Peach Bottom Atomic Power Station, Units 2 & 3
Facility Operating License Nos. DPR-44 and DPR-56
NRC Docket Nos. 50-277 and 50-278

Subject: Supplement to the Request for License Amendments Related to Application of Alternative Source Term, dated July 14, 2003

Exelon Responses to the NRC's Requests for Additional Information

Figure 2: Leak Rate Vs. Time, Calculated and Assumed

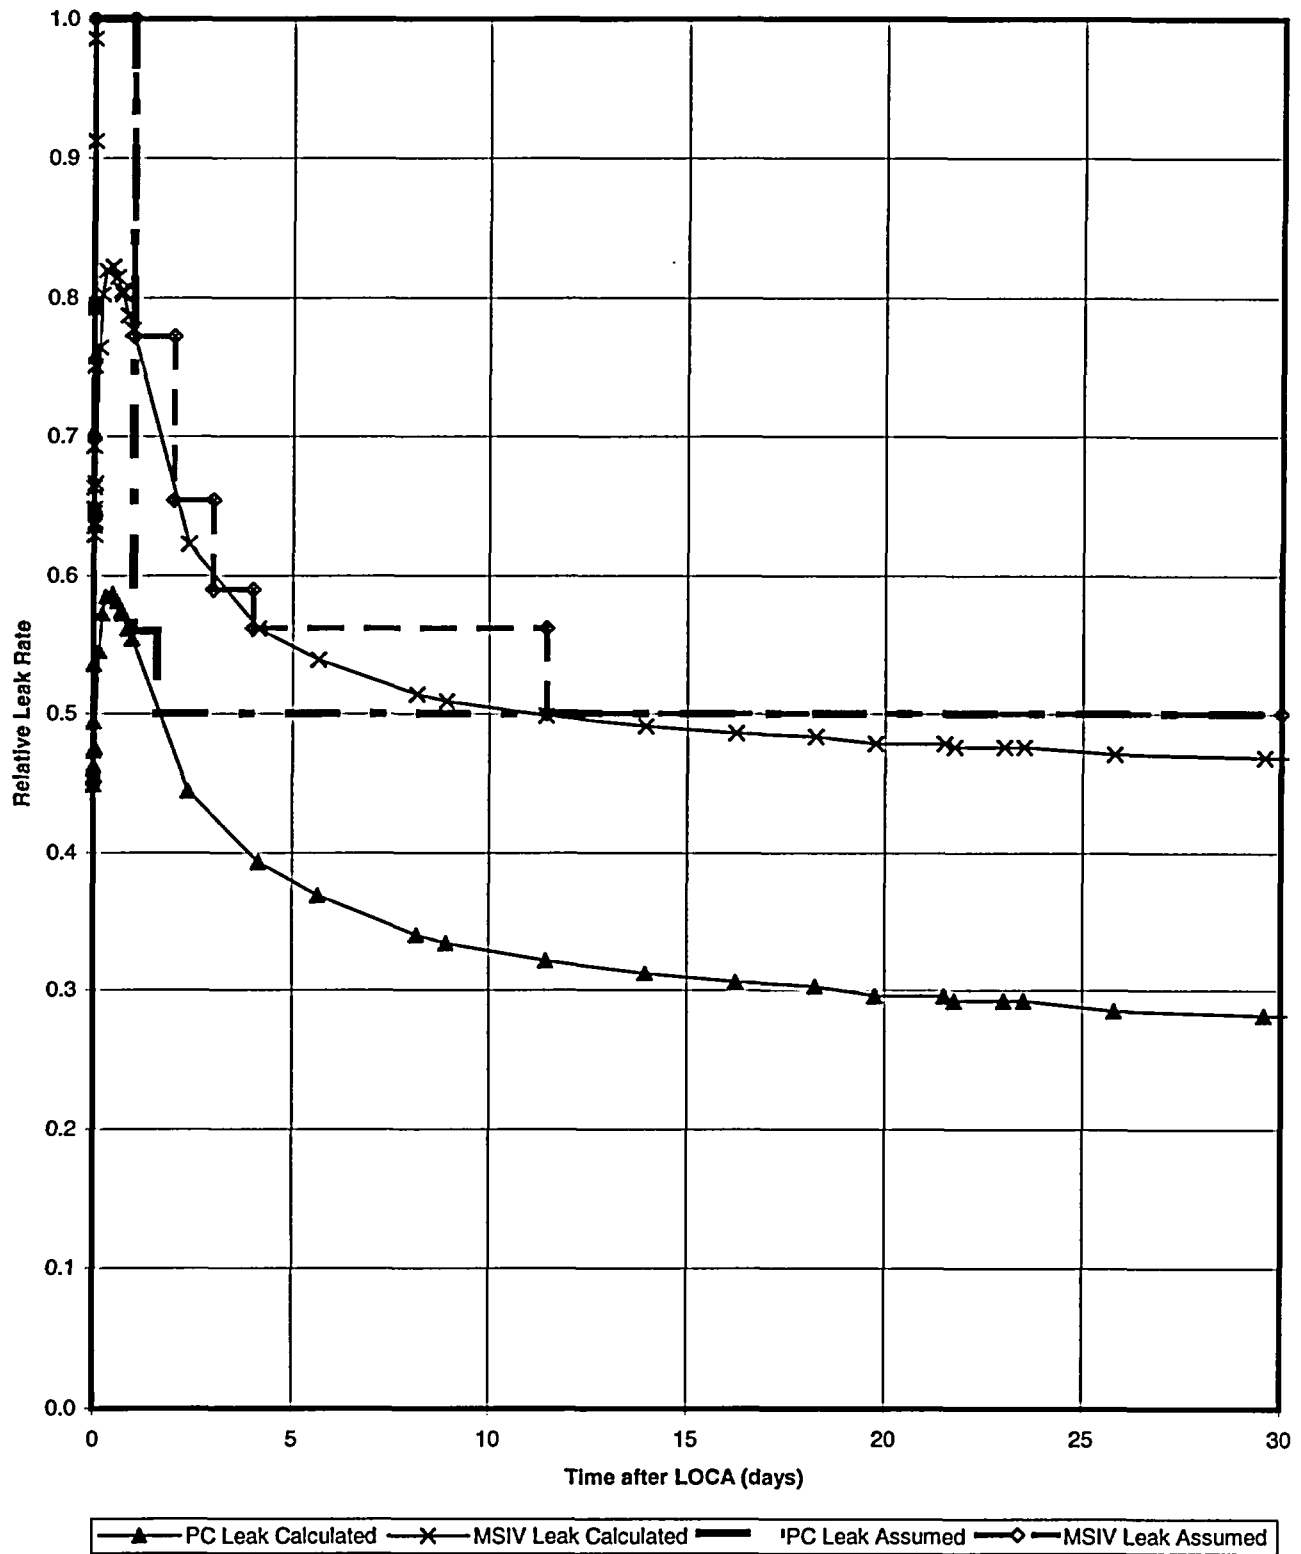
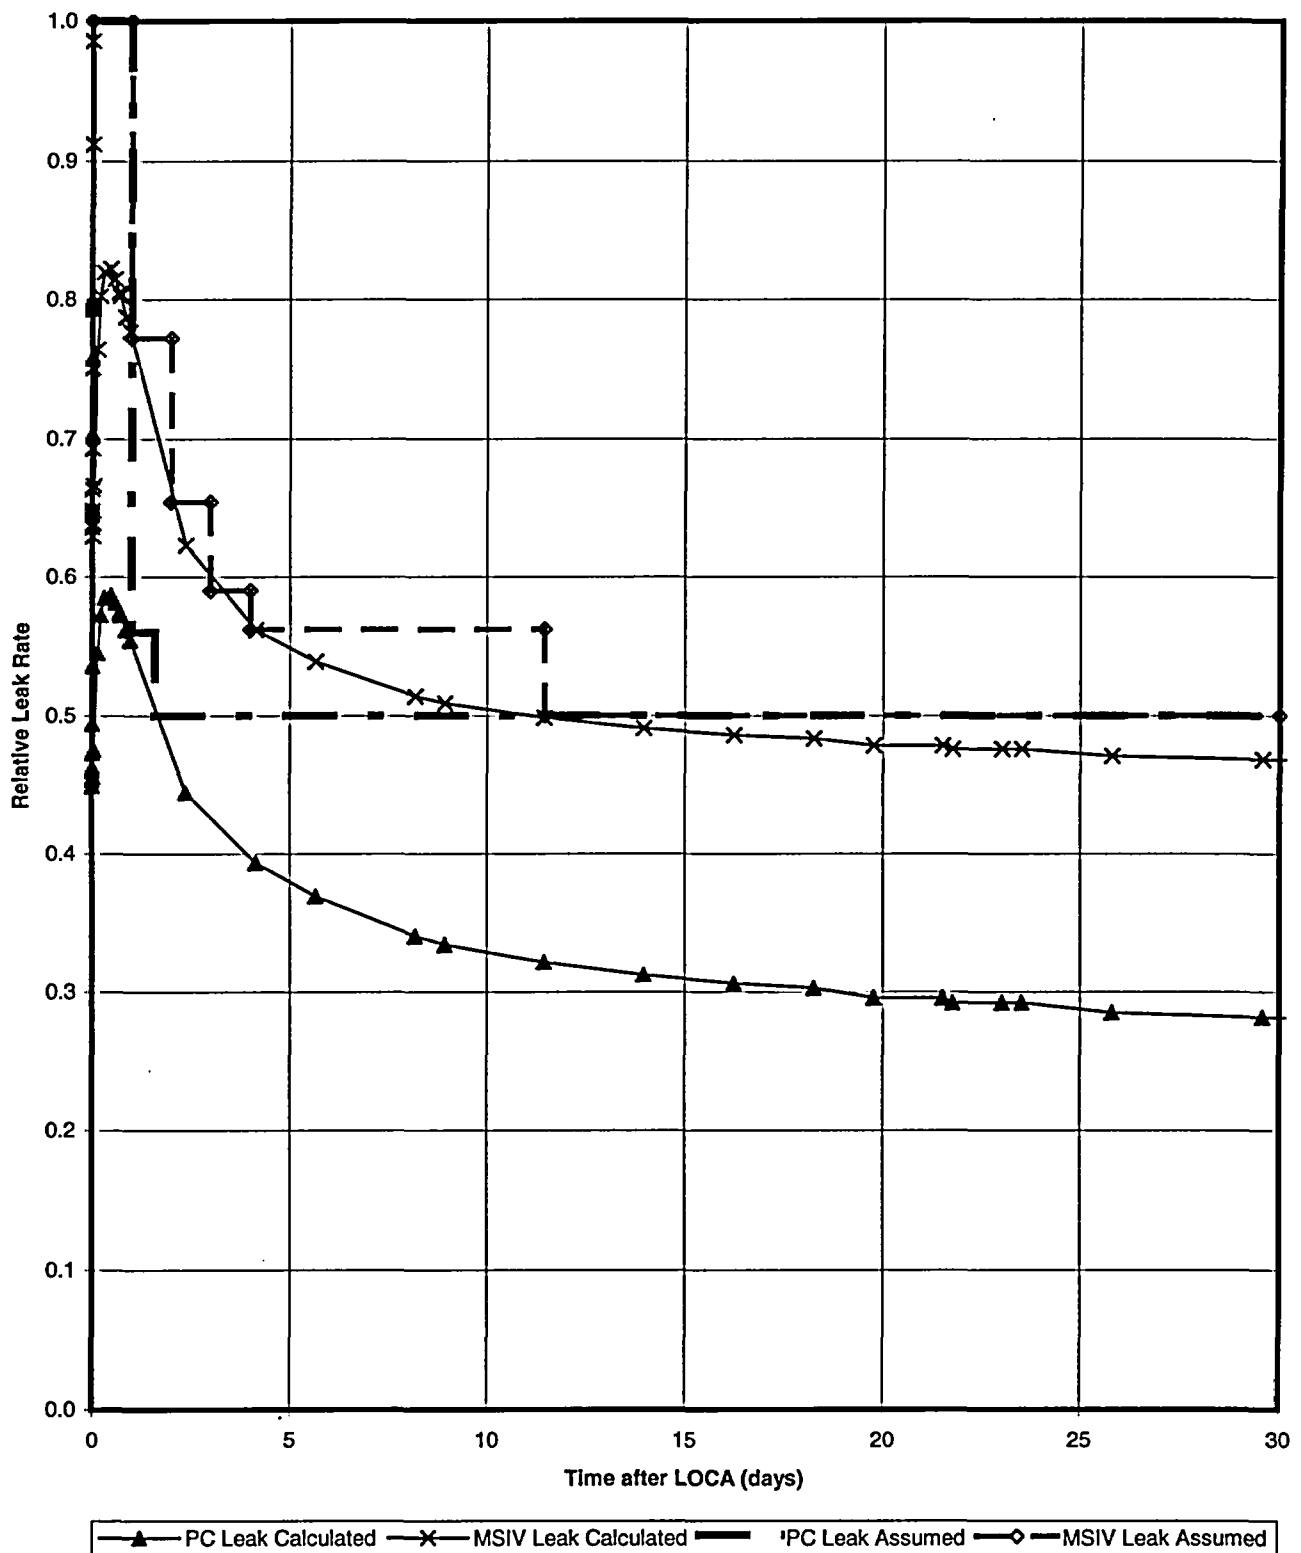
9. In Reference 2, Attachment 1, page 13, PBAPS states that an alternate method of evaluating leak rates is now being applied. The staff requests additional information regarding the methodology used to determine the predicted leak rate of 0.437 cfm in the maximum line at containment conditions. Please provide the calculations and assumptions used to determine this leak rate. For the leakage rates in each main steam isolation valve piping segment describe the method used to determine the flow rates.

indicated in the Attachment 3: Drywell Pressure Data, and Attachment 4: Leak Reduction Assessment. Attachment 3: F2-Leak Rate Reduction illustrates how leak rates are conservatively modeled in comparison to as-conservatively-calculated values.

1. PC Leakage other than MSIV is assumed to be reduced to 56% La after 1 day and 50% La after 38 hours based on PM-1061 results.
2. MSIV Leakage reductions are based on the 1a and 7 formulations, whichever is limiting. Sheet "Drywell Pressure Data" and "F2-Leak Rate Reduction" show the step-wise, conservatively bounding assumptions.
